Access Compliance Report

Public Rights-of-Way (Curb Ramps)

Intersection ID: N/A	Main Street: BRECKFIELD_CT	Cross Street: KIRKWYND_COMMONS_DR	Location: S
ADA ID: CE09FD750D71	Ramp Type: Perp	Initial Pass/Fail: Fail	Overall Compliance: No
		Severity Score: 12.5

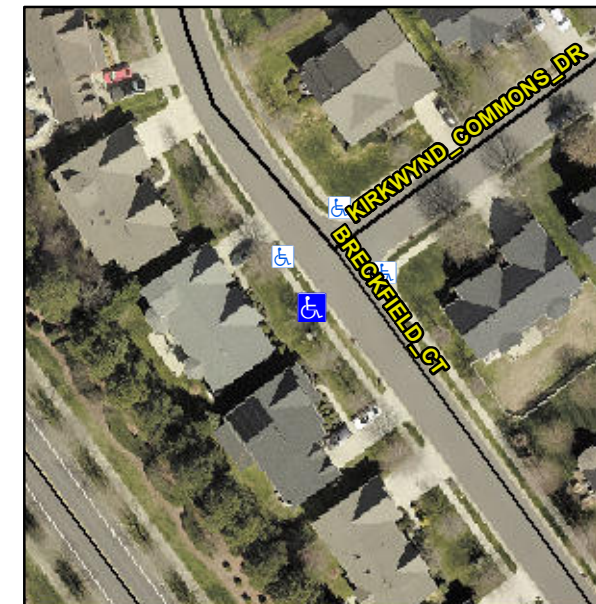
R304.2.2

Compliance	Description	Data	Compliance	Description	Data
N/A	Ramp Length (in)	48.0	No	Ramp Slope (%)	11.2
Yes	Ramp Width (in)	48.0	Yes	Ramp XSlope (%)	1.3
N/A	Flare Type LT	N/A	N/A	Flare Type RT	N/A
N/A	Flare Slope LT (%)	N/A	N/A	Flare Slope RT (%)	N/A
N/A	Flare Traversable LT?	N/A	N/A	Flare Traversable RT?	N/A
N/A	Landing Length (in)	N/A	N/A	DWS Provided?	N/A
N/A	Landing Width (in)	N/A	N/A	DWS Contrast?	N/A
N/A	Landing Slope (%)	N/A	N/A	DWS Length (in)	N/A
N/A	Landing X Slope (%)	N/A	N/A	DWS Full Width?	N/A
N/A	Landing Curb? (Y/N)	N/A	N/A	DWS Offset (in)	N/A
N/A	Shared Landing?	N/A			
N/A	Gutter Ponding?	N/A	N/A	Gutter Slope (%)	N/A
N/A	Gutter Lip Ht (in)	N/A	N/A	Gutter X Slope (%)	N/A
N/A	Painted X Walk1?	No	N/A	Painted X Walk2?	N/A
	X Walk 1 Direction	To NE		X Walk 2 Direction	N/A
N/A	X Walk 1 Width (in)	N/A	N/A	X Walk 2 Width (in)	N/A
	X Walk 1 Slope (%)	3.8		X Walk 2 Slope (%)	N/A
	X Walk 1 X Slope (%)	2.1		X Walk 2 X Slope (%)	N/A

Remove & Replace Entire Ramp.
